### STAFF REPORT RECOMMENDATION

*October 10, 2017*

**FILE NUMBER:** TP 17-02: Parker Knoll

**REQUEST:** The applicant is seeking approval of an eleven-lot Subdivision in the “R-8” Single-Family Dwelling District and “I” Institutional District. A portion of the subdivision road access will be accommodated within a 50-foot wide easement in Wesley Lynn Park.

Figure 3: Proposed Site Plan

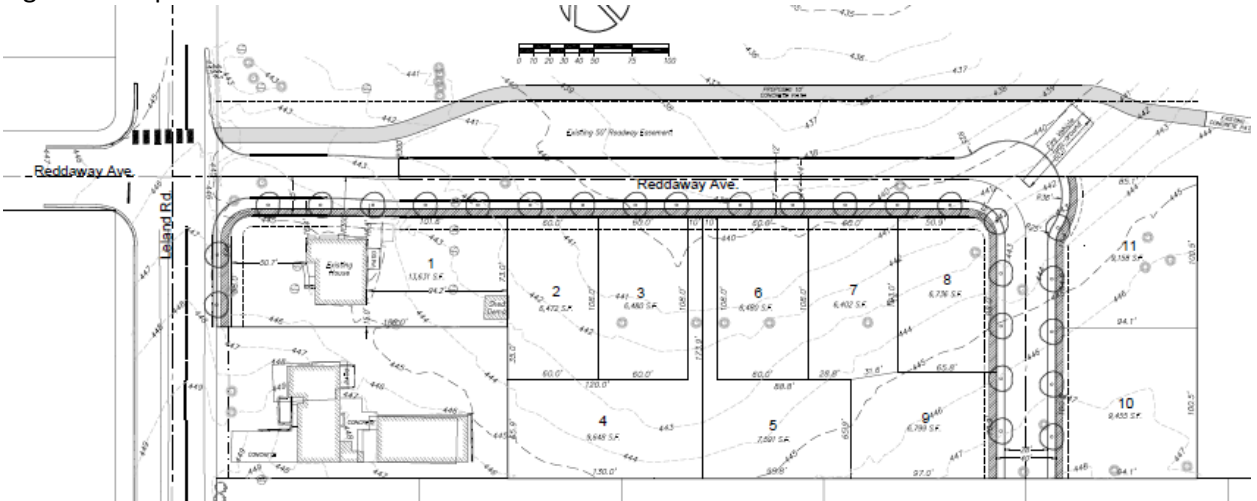
This response implies that the east-west segment will not be completed in its entirety, and has not been updated to reflect the most recent proposals and discussions with City staff. The current proposal, supported by the City, is to construct the east-west segment of the street in its entirety as a constrained street with 28-foot pavement width. The portion south of the park property line will conform fully to City standards, with 5-foot sidewalk and planter strip, within dedicated public ROW. The portion north of the park property line is proposed to be constructed as a private street built to public standards. Due to the restrictions of the park's Charter, the portion on park property cannot be dedicated as public ROW. The fee ownership in the easement area is owned by the City; therefore, the City will maintain the complete road cross-section, even though a portion of it is subject to a private easement. It will remain open for public road use providing adequate facilities for local vehicular traffic. On a practical level, the function and features of this split private-public street will be indistinguishable from a fully public

For the north-south segment, the applicant proposes a 40-foot ROW with 28-foot pavement and planter strips within the ROW, with sidewalks placed outside the ROW in an easement. The applicant has not provided justification for placing sidewalks in easements, and staff does not support this proposal without adequate justification. The sidewalk along Reddaway Avenue shall be located within the ROW, either by dedicating 50 feet of ROW south of the proposed bend (to accommodate planter strip), or by proposing a curb-tight sidewalk within a 40-foot ROW. The ROW improvements for this section of Reddaway Ave shall consist of 28 feet of pavement (2) 0.5' Curb, (2) 5' planter with street trees, (2) 5' sidewalk, (2) 0.5' behind sidewalk, and streetlights.

3. Reddaway Ave from Leland Road easterly to the proposed bend shall have improvements consisting of 28 feet of pavement (2) 0.5' Curb, (1) 5' planter with street trees along the south side, (1) 5' sidewalk along the south side, (1) 0.5' behind sidewalk along the south side and streetlights. The applicant shall dedicate a minimum of 27-feet of right-of-way (ROW) south of the northern property line, or that width required to fully encompass the 5-foot sidewalk and 0.5-foot public access strip. (DS)

4. Reddaway Avenue south of the proposed bend shall consist of 28 feet of pavement, (2) 0.5' Curb, (2) 5' planter with street trees, (2) 5' sidewalk, (2) 0.5' behind sidewalk, and streetlights. (DS)

5. The sidewalk along Reddaway Avenue shall be located within the ROW, either by dedicating 50 feet of ROW south of the proposed bend (preferred), or with a curb-tight sidewalk within the proposed 40-foot ROW. (DS)

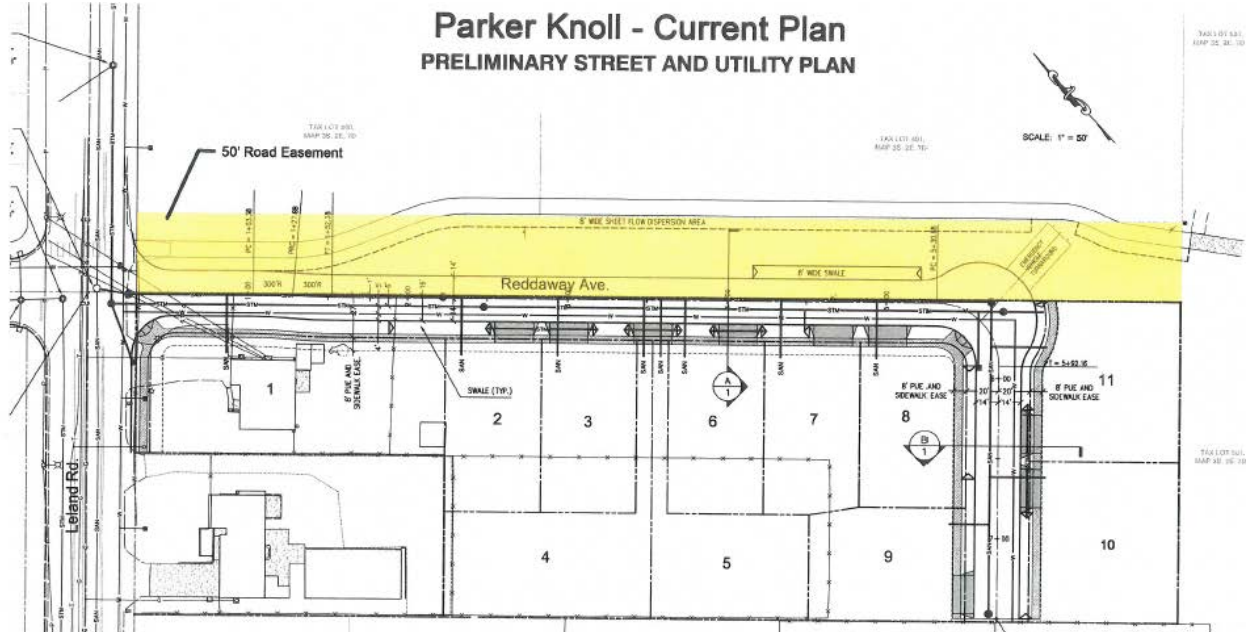
The applicant proposed to utilize an existing easement (shown below in yellow) to accommodate a portion of the roadway on the Wesley Lynn Park property. Though the easement grants the applicant rights to develop a portion of Wesley Lynn Park, according to the Oregon City Charter, certain development of park property requires approval of Oregon City voters. The easement area has twice been the subject of election proposals that would have allowed locating a roadway, drainage and utilities necessary to support the development on park land. As the elections both were narrowly defeated, the applicant revised the design to include a public road within a portion of the easement as well as a concrete path, both within

and outside of the easement area, which they believe is authorized by the easement and does not require voter approval.

**The improvements proposed within the easement area include a portion of a local roadway, 12 feet of pavement area, a drainage swale necessary to collect runoff from the roadway only, plus a 10 foot concrete path for use by residents as well as park attendees. The question for the City Commission to**
